PCN – Process Change Notification

Change:	MA230&MA231 Antenna Series
Date:	2016/03/08
Author	Kim Ho

Old drawing

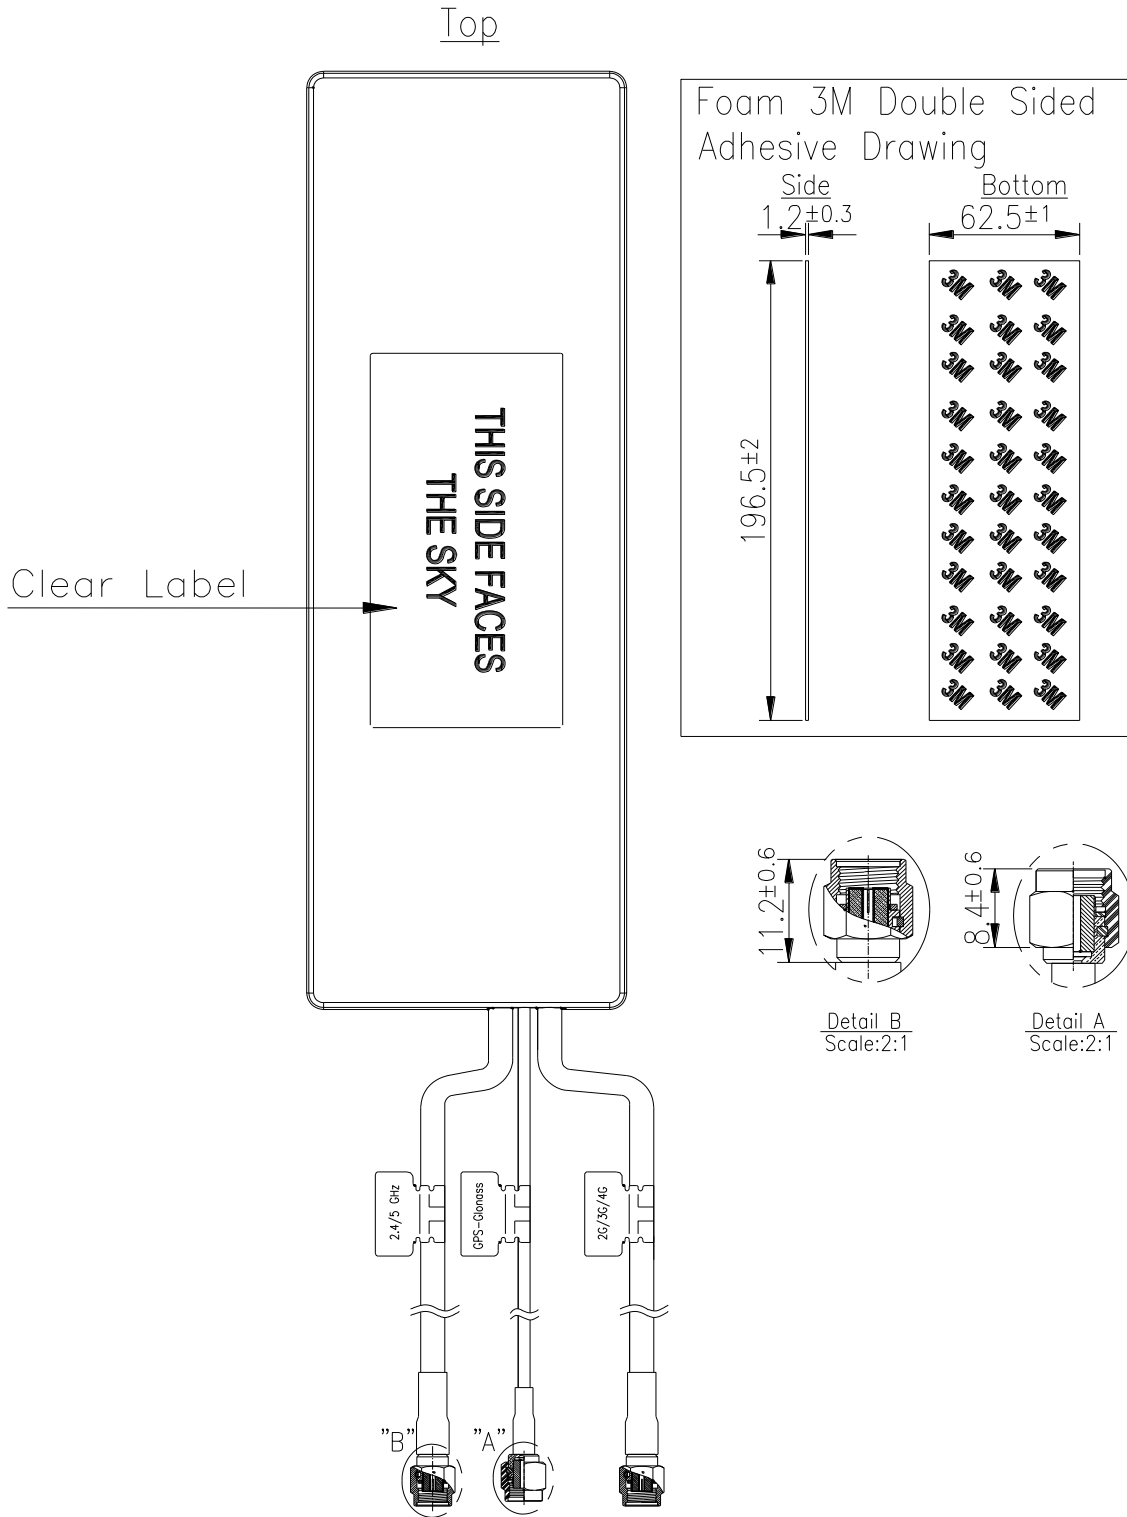
1. Amend adhesive foam type, dimensions.
2. Amend connector.
3. Add barcode label.
4. Clear label finish color Transparent to Black on bom.
